**Project Name** Choctaw Point Container Terminal – Phase V Dock Extension

**March 4, 2026**

**ADDENDUM NO. 1**

# Alabama Port Authority

CLIENT DWG NO:	
CHOCTAW POINT CONTAINER TERMINAL PHASE V DOCK EXTENSION PROJECT LOCATION PLAN & SITE VICINITY MAP	
FOR: ALABAMA PORT AUTHORITY	
PROJECT NO: 4617	DWG NO: G3
REVISION: F

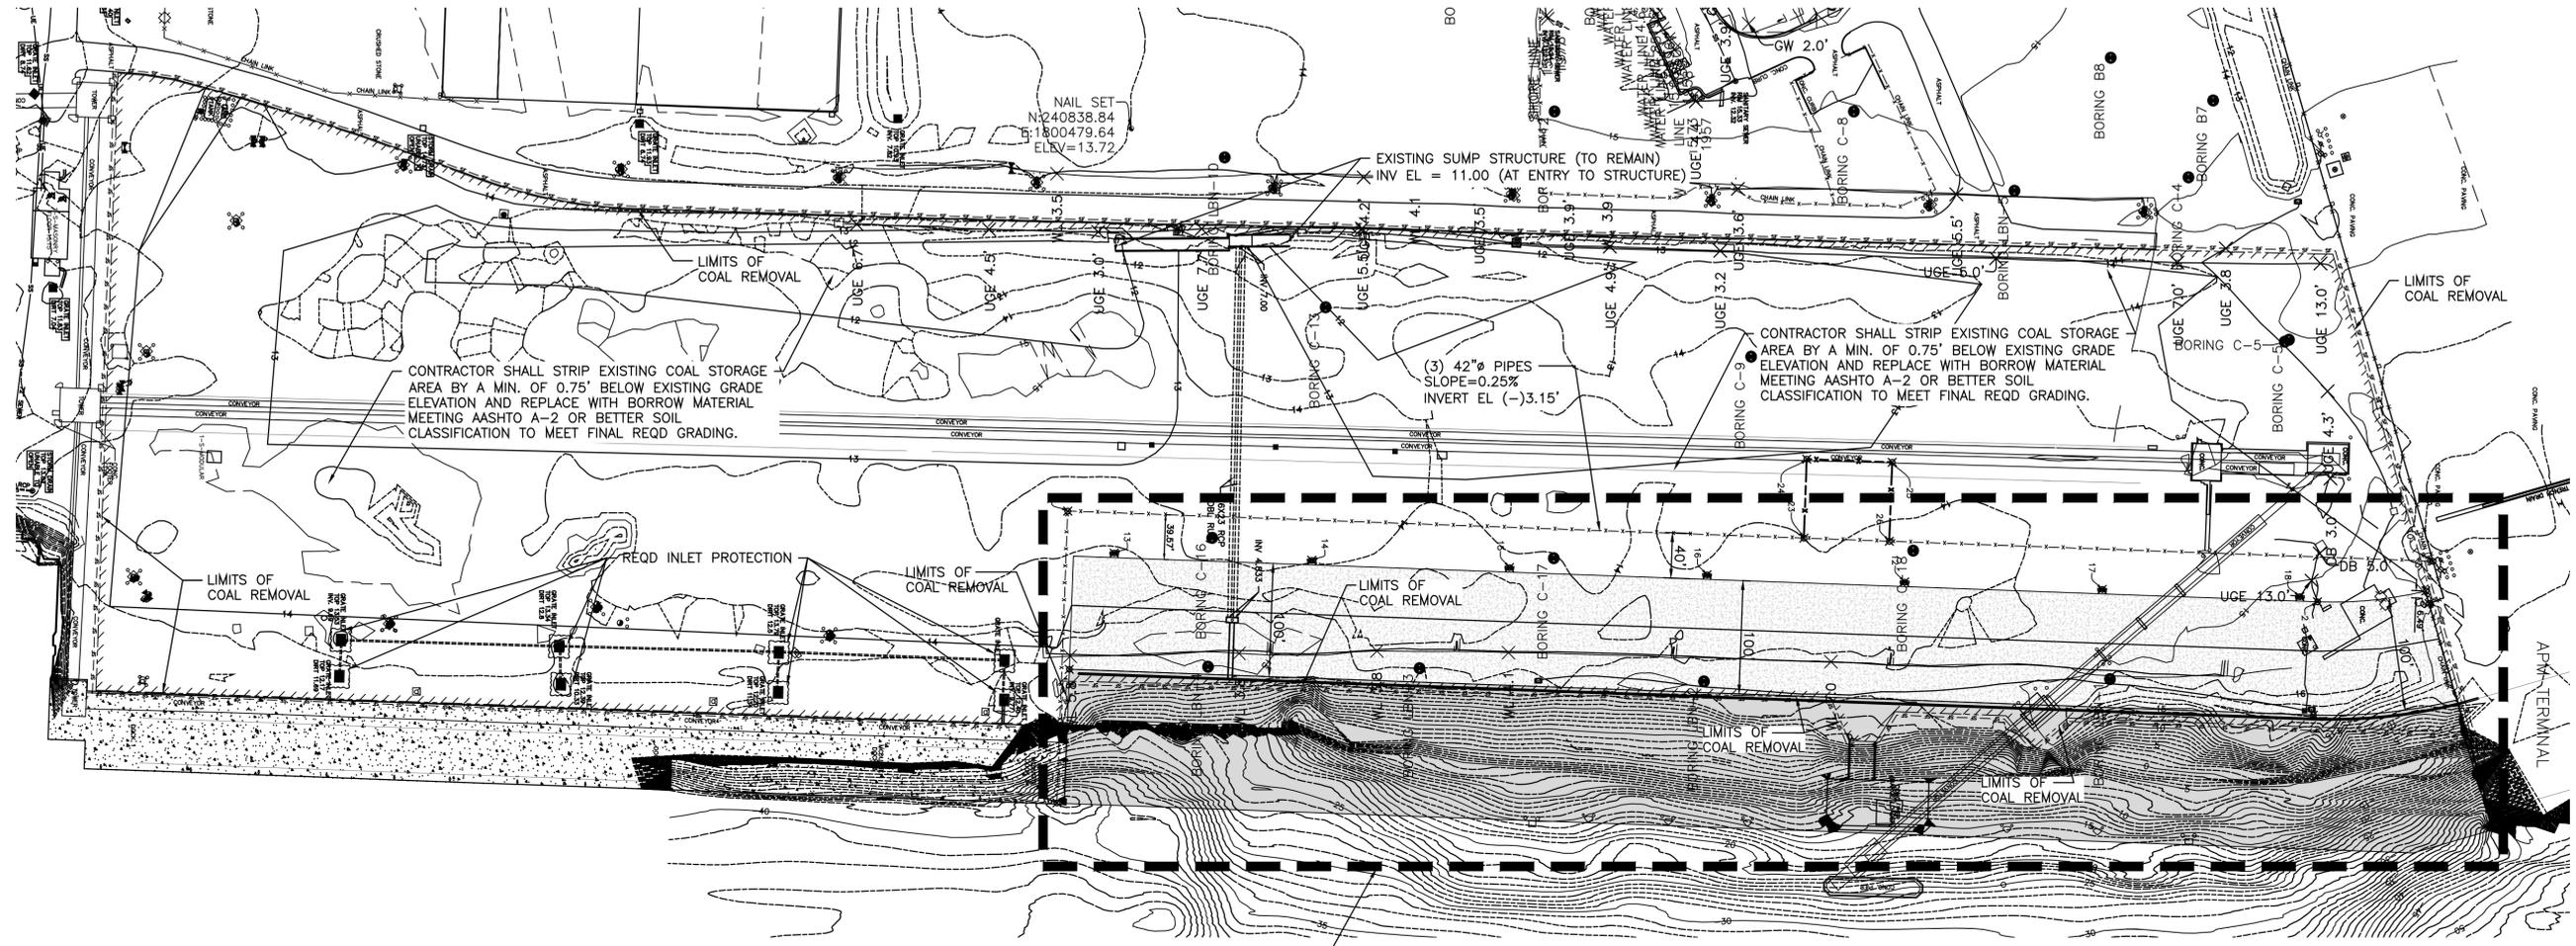
NO.	REVISION	DATE	APPD	CK'D	DRAWN	RSG	MED	ECW
F	ADDED NOTE	03-02-26				RSG	MED	ECW
E	ISSUED FOR BID	01-14-26				RSG	MED	RST
D	100% DESIGN REVIEW	09-09-25				RSG	MED	RST
C	95% DESIGN REVIEW	08-08-25				RSG	MED	RST
B	60% DESIGN REVIEW	6-10-25				RSG	MED	RST
A	30% DESIGN REVIEW	04-11-25				RSG	MED	RST
